FCC Class II Permissive Change for FCC ID: ZNFHBS-XL7

This is to request a Class II permissive change for FCC ID: ZNFHBS-XL7 , originally granted on May 22, 2019
The device is identical to the previously certified LG STEREO Headset except for the modification following:

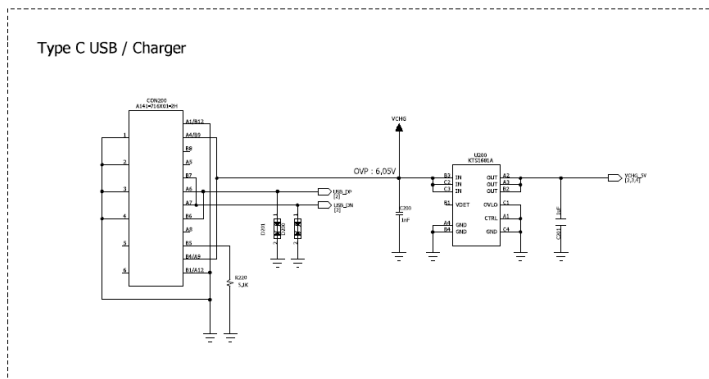
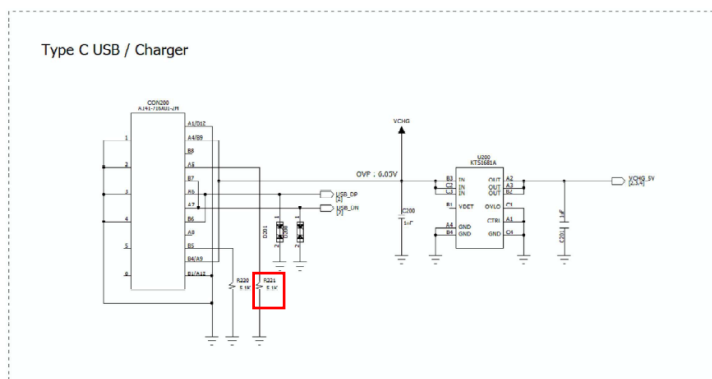
- Add Pull down resistor(R221, 5.1K) to improve reverse charging on TYPE-C adapters. Please refer below shcematics.
